RE: 722 Crossway Rd. Burlingame, CA
Resubmittal with request for alterations to design.

3/27/19

To the Design Counsel Board,

PAGE (9)

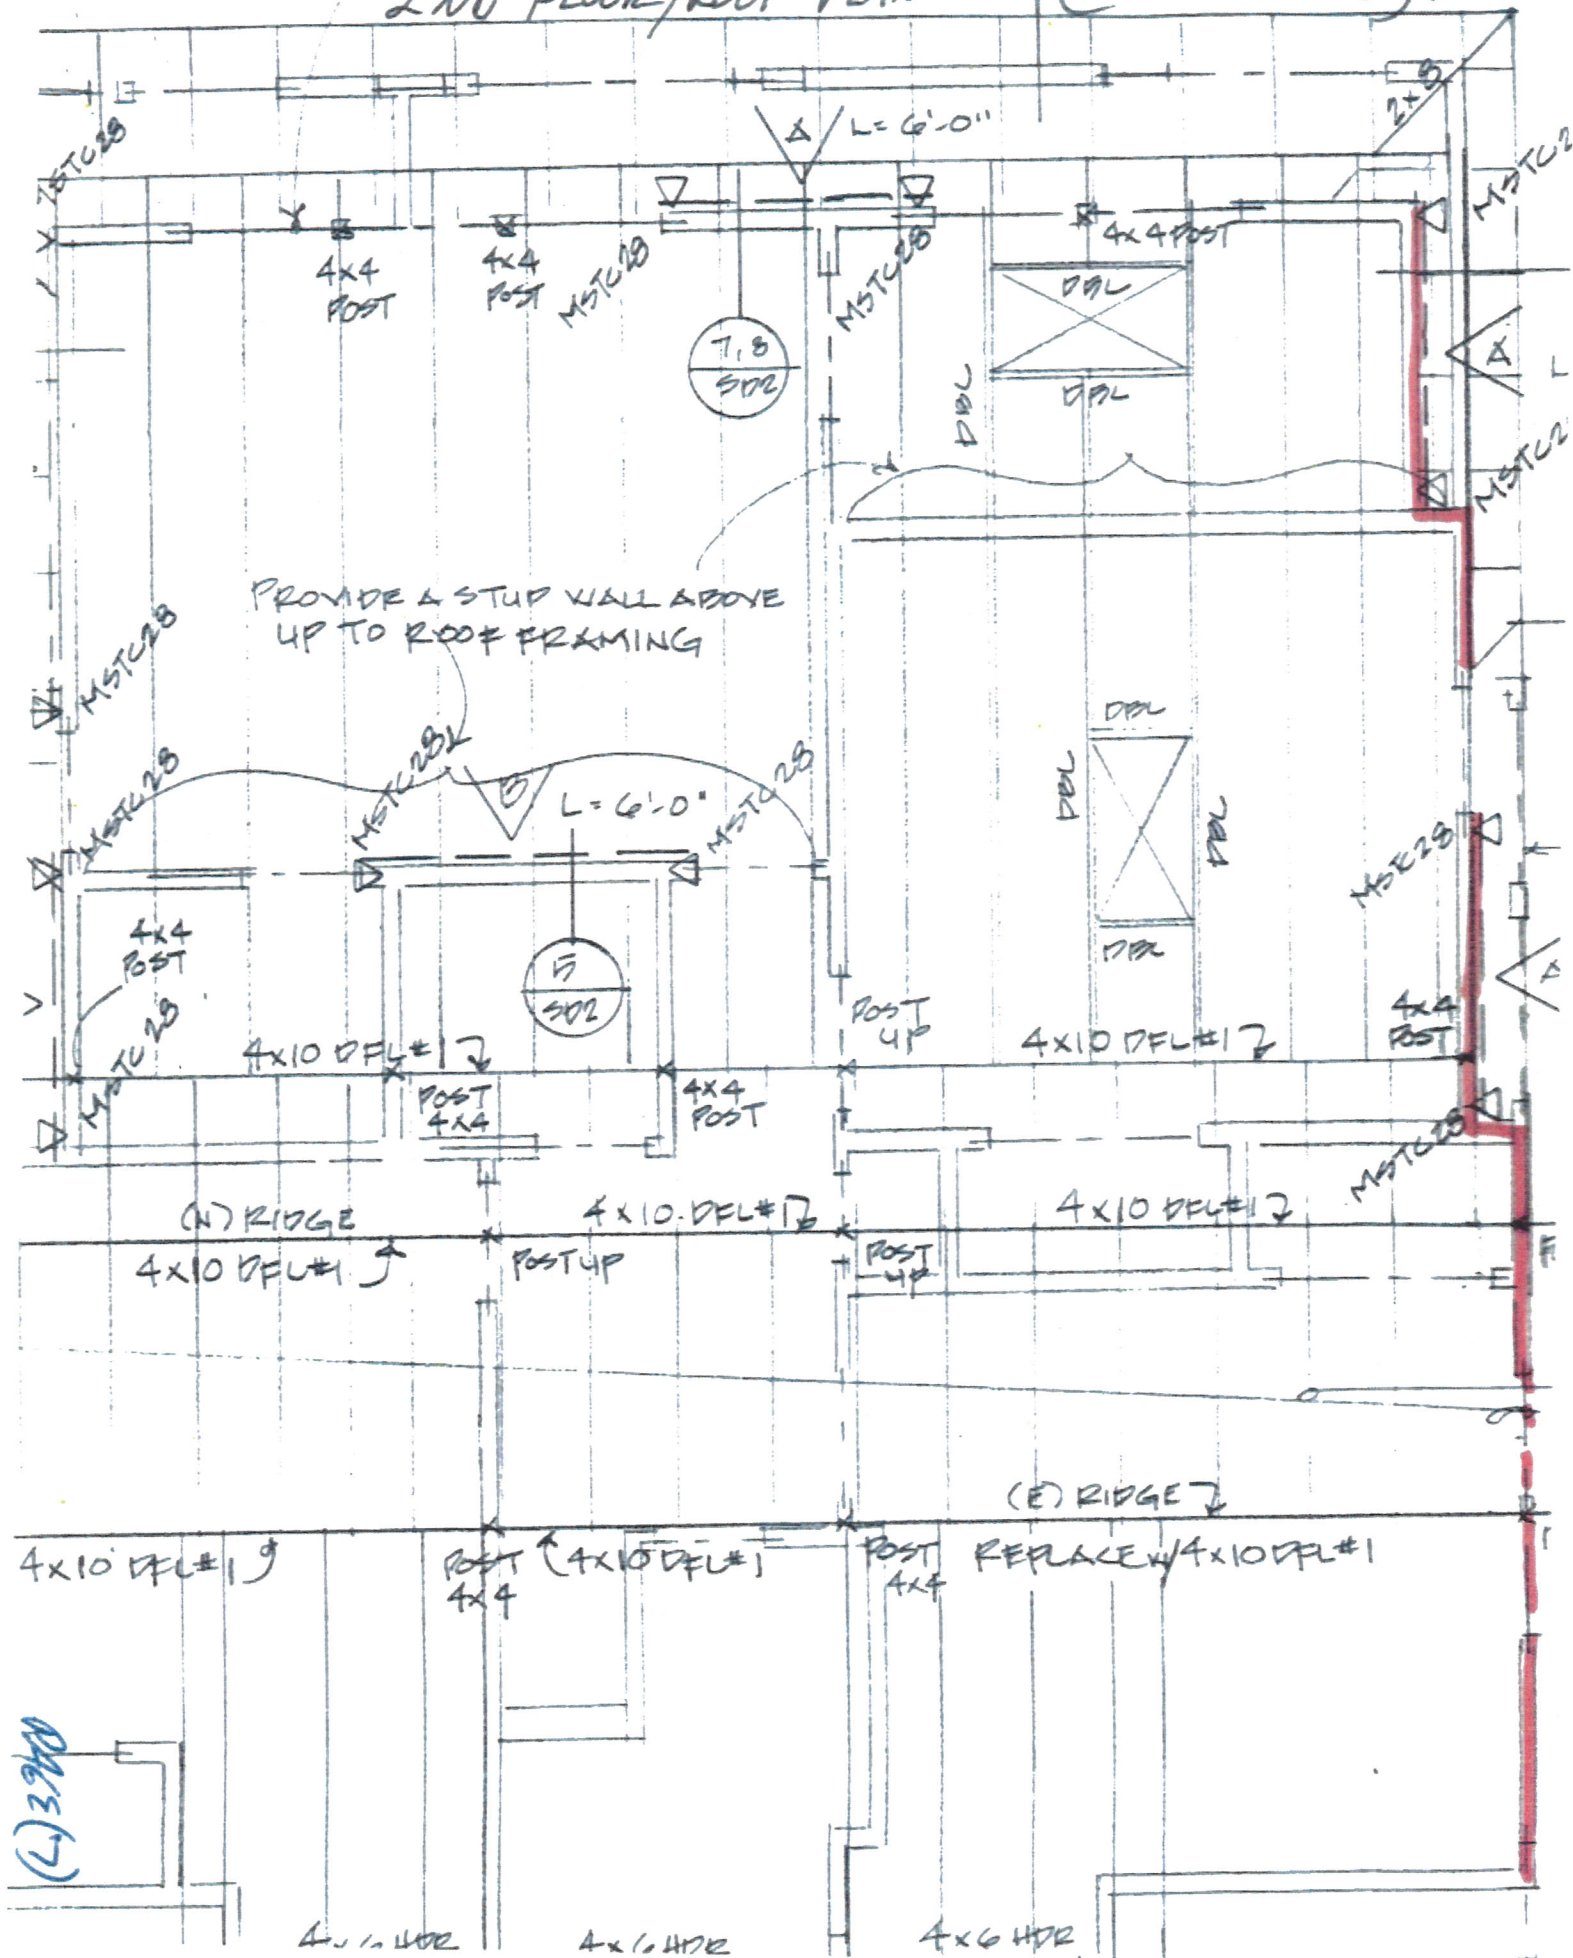
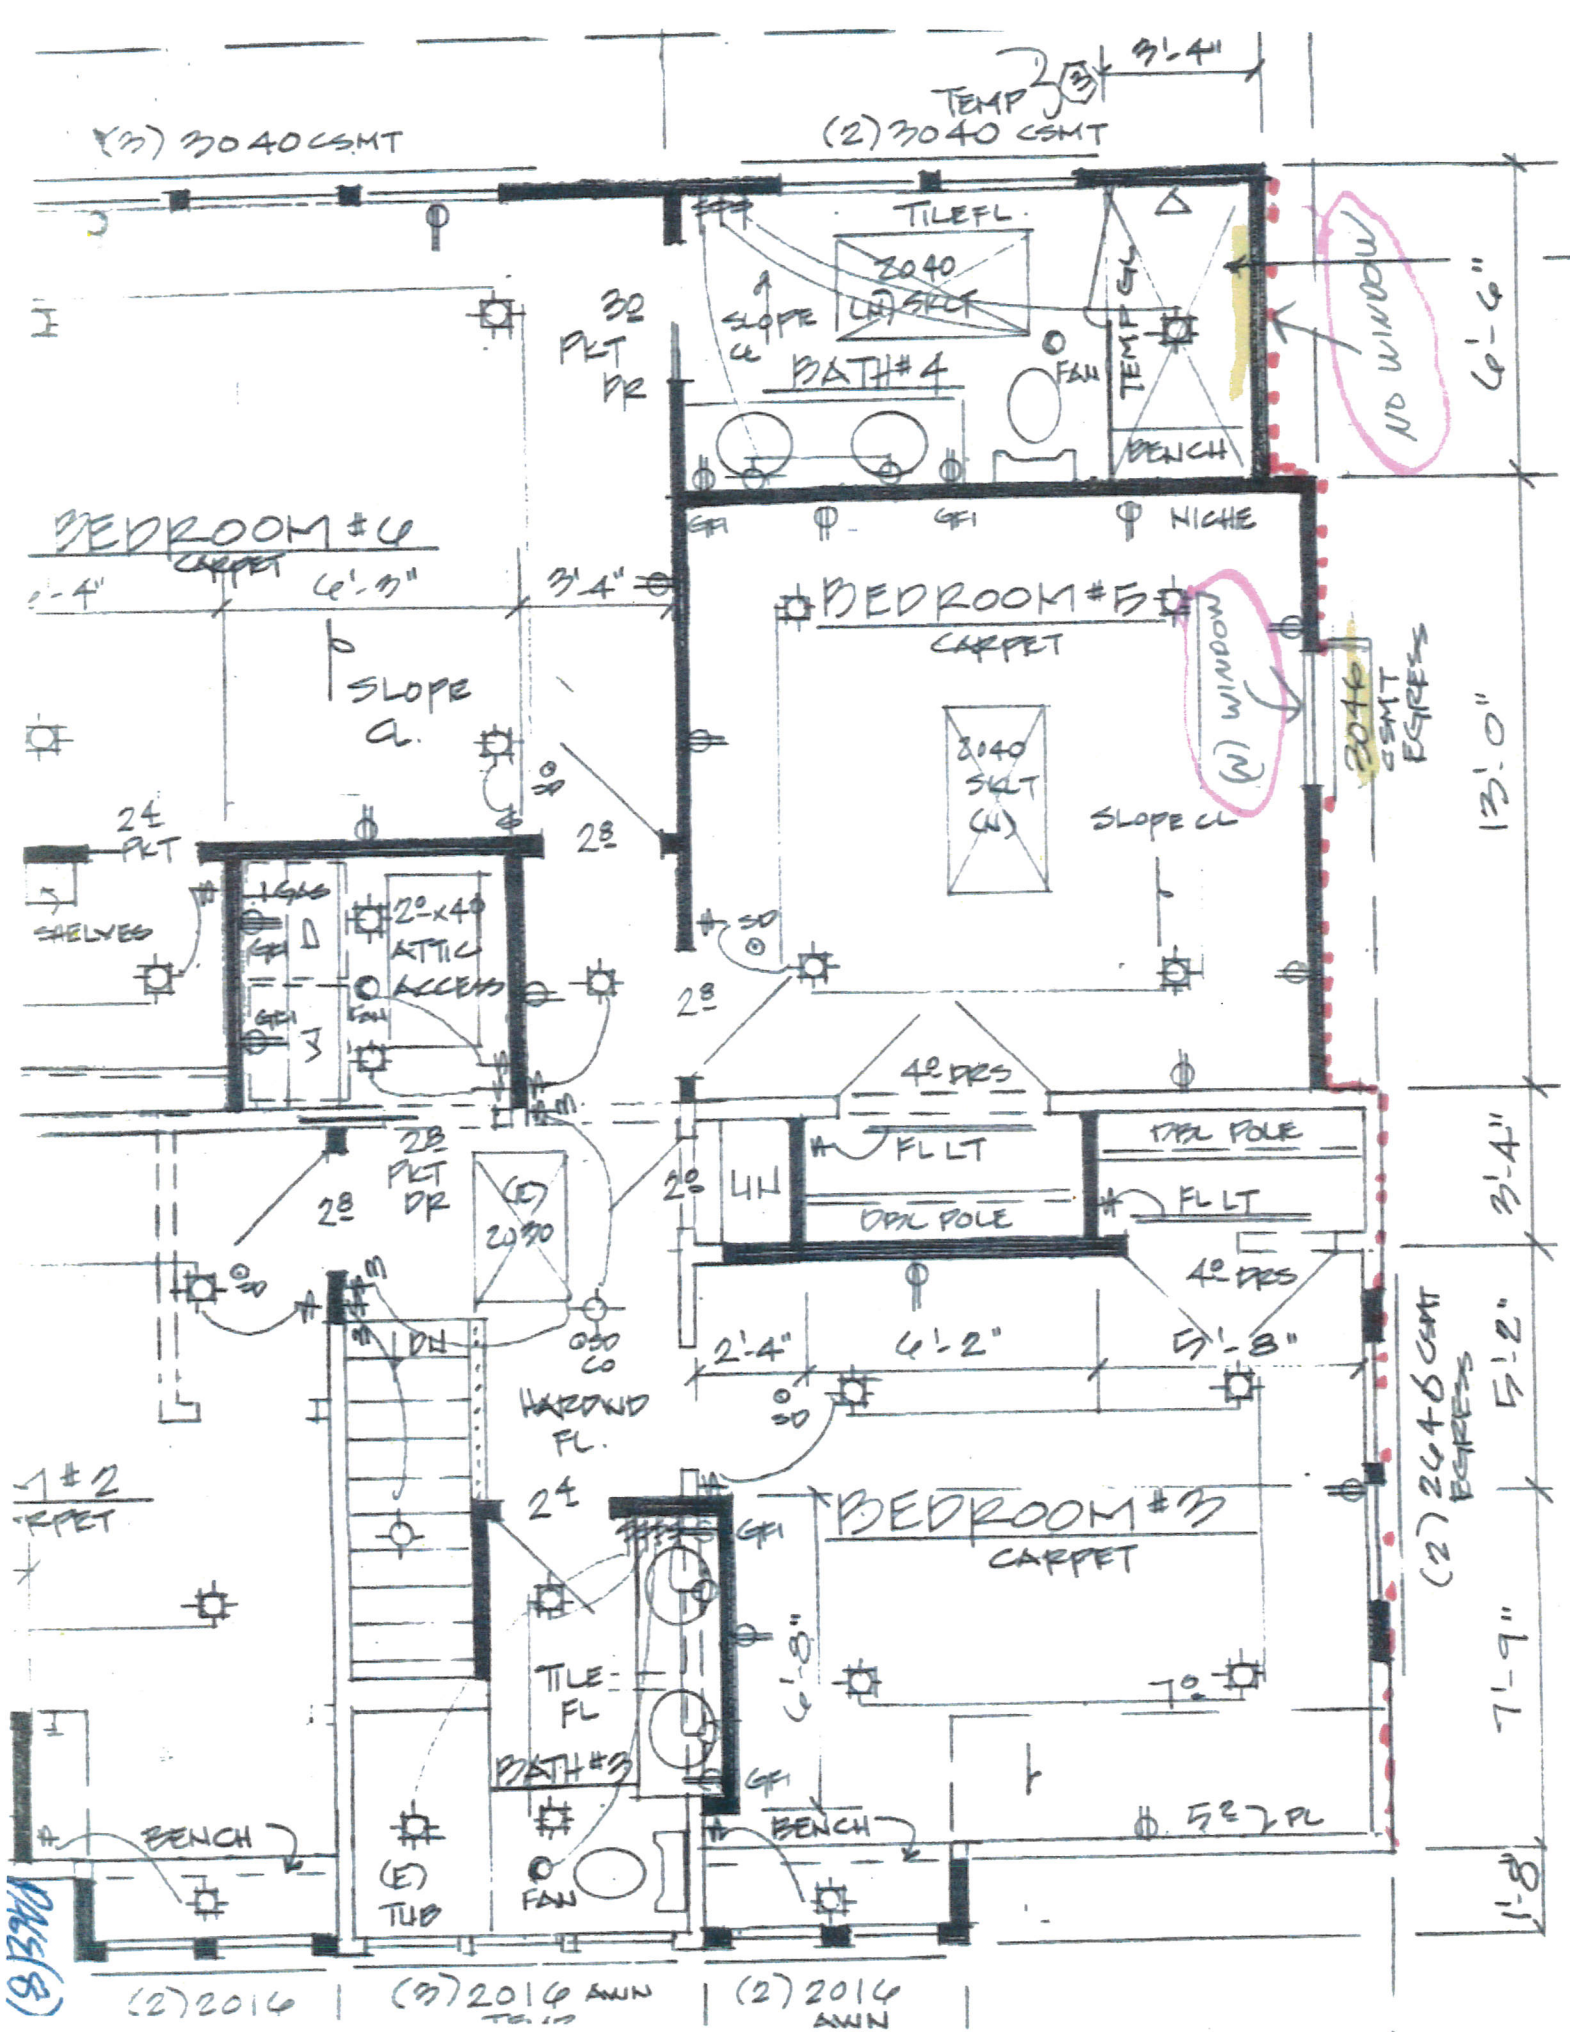
Pages 9 & 10 are pictures showing the, "As Is" existing look of the house for general reference.
